Access Compliance Report

Public Rights-of-Way

Intersection ID: 27397	Main Street: ELM_LN	Cross Street: BALLANTYNE_COMMONS_PY	Location: NE
ADA ID: A48684D779C2	Ramp Type: Perp	Initial Pass/Fail: Fail	Overall Compliance: No
Severity Score: 22.5			
Codes/Mitigation Info/Possible Solution		Field Measurements/Component Compliance

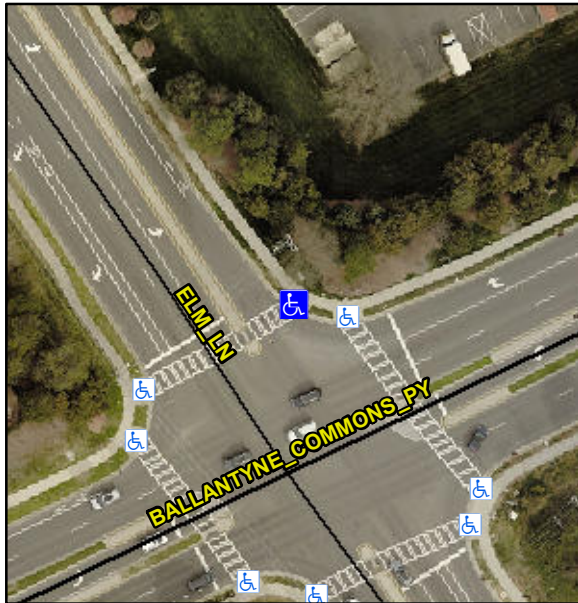
R304.5.1, R304.2.2, R304.5.3

Compliance	Description	Data	Compliance	Description	Data
N/A	Ramp Length (in)	47.0	No	Ramp Slope (%)	9.4
No	Ramp Width (in)	47.5	No	Ramp XSlope (%)	2.5
N/A	Flare Type LT	N/A	N/A	Flare Type RT	N/A
N/A	Flare Slope LT (%)	N/A	N/A	Flare Slope RT (%)	N/A
N/A	Flare Traversable LT?	N/A	N/A	Flare Traversable RT?	N/A
N/A	Landing Length (in)	N/A	N/A	DWS Provided?	N/A
N/A	Landing Width (in)	N/A	N/A	DWS Contrast?	N/A
N/A	Landing Slope (%)	N/A	N/A	DWS Length (in)	N/A
N/A	Landing X Slope (%)	N/A	N/A	DWS Full Width?	N/A
N/A	Landing Curb? (Y/N)	N/A	N/A	DWS Offset (in)	N/A
N/A	Shared Landing?	N/A			
N/A	Gutter Ponding?	N/A	N/A	Gutter Slope (%)	N/A
N/A	Gutter Lip Ht (in)	N/A	N/A	Gutter X Slope (%)	N/A
N/A	Painted X Walk1?	Yes	N/A	Painted X Walk2?	N/A
	X Walk 1 Direction	To SW		X Walk 2 Direction	N/A
N/A	X Walk 1 Width (in)	113.0	N/A	X Walk 2 Width (in)	N/A
	X Walk 1 Slope (%)	0.8		X Walk 2 Slope (%)	N/A
	X Walk 1 X Slope (%)	0.6		X Walk 2 X Slope (%)	N/A

Remove & Replace Entire Ramp.
